# Town of Franklin

## Conservation Commission

**To:** Franklin Conservation Commission  
**From:** Breeka Li Goodlander, CWS, PWS, CERPIT  
**Re:** Conservation Agent Report  
**Date:** April 4, 2024

##### 2.2.1 3 Sewall Brook Court

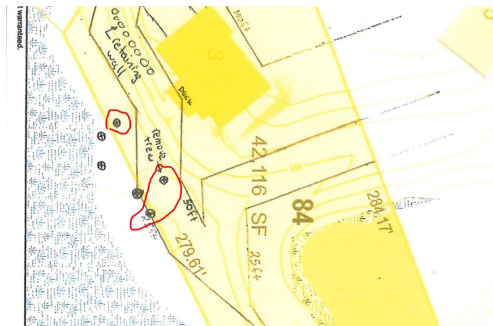
This application is for the removal of three trees at 3 Sewall Brook Court within the 0- to 25-foot “No Touch” to Bordering Vegetated Wetlands. The Applicant has had trees removed in this area before (2021) with stumps left in place. Commission should confirm method of removal and access to remove the trees given the topographic relief and proximity to resource areas.

Commissioner’s please note that the application is requesting the removal of six trees total, however only three of these trees are located on the property of 3 Sewall Brook Court (circled in red below). There are an additional three trees within the abutting Town property (Conservation land) and within wetlands that the Applicant would like to be removed.

The Applicant has provided a letter from Tree Tech, Inc. noting that the additional trees on Town property are vulnerable to uprooting in wet ground which is typical of trees in wetlands, but not that they have uprooted, are diseased, girdled, or otherwise deemed legally hazardous. Tree Tech, Inc. has noted that the trees are within striking distance of the house. Agent and arborist from DPW to assess conditions of trees on Tuesday, April 9 and will top and/or remove trees as necessary. Agent will seek permitting and, if necessary, ratification of an emergency authorization by the Commission should the trees be a cause for concern.

Recommend approval of the three trees within the Applicants private property only with stumps left in place. A boundary marker is located on the Applicants property to help the tree company and Applicant denote where the property boundary lies.
